ABBOTT ADD	INDEX TECHNICAL SERVICE BULLETIN
---	---

PRODUCT: ALCYON (TM) 300 ISE (122)	DATE: 23-SEP-98
--	---------------------------

ALCYON (TM) Rev. 0 Software Release Ver. 261095/0142TSB#: **122-002**ORIGINATOR: **Emile Diou/Bernard Dabosi**APPROVED: **Christie McCain 05/21/98**

Modified Wash Pump With New O-RingTSB#: **122-001**ORIGINATOR: **Gary Tompkins/Bernard Dabosi**

Figure 1

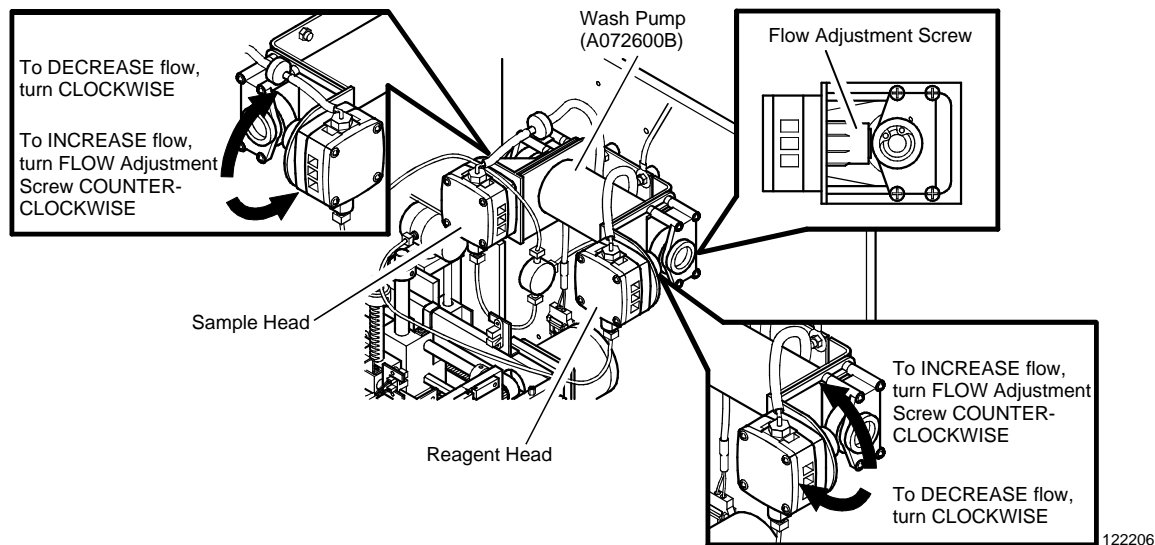
- If the volume from the reagent head is less than 25ml, turn the reagent flow adjustment screw (see **Figure 1**) in the counter-clockwise direction for 1/16 of a turn to increase the flow. Repeat the Flow Check.
- Perform the Solenoid Valve Check to verify that the valve does not leak. If the volume from the reagent head is greater than 25ml and less than 30ml but the solenoid valve leaks, turn the reagent flow adjustment screw (see **Figure 1**) in the clockwise direction for 1/16 of a turn to decrease the flow to 25ml. The pressure may be too high, causing the valve to leak. (More than one adjustment may be necessary.) Repeat the Flow Check.
- Repeat the Solenoid Valve Check. If the reagent solenoid valve continues to leak and the volume is right at the target value of 25ml, replace the valve (A143600B) then repeat all the checks.

- If the volume from the sample head is less than 60ml, turn the sample flow adjustment screw (see **Figure 1**) in the counter-clockwise direction for 1/16 of a turn to increase the flow. Repeat the Flow Check.
- Perform the Solenoid Valve Check to verify that the valve does not leak. If the volume from the sample head is greater than 60ml and less than 80ml but the solenoid valve leaks, turn the sample flow adjustment screw (see **Figure 1**) in the clockwise direction for 1/16 of a turn to decrease the flow. The pressure may be too high, causing the valve to leak. (More than one adjustment may be necessary.) Repeat the Flow Check then the Solenoid Valve Check.
- Repeat the Solenoid Valve Check. If the sample solenoid valve continues to leak and the volume is right at the target value of 60ml, replace the valve (A143500B) then
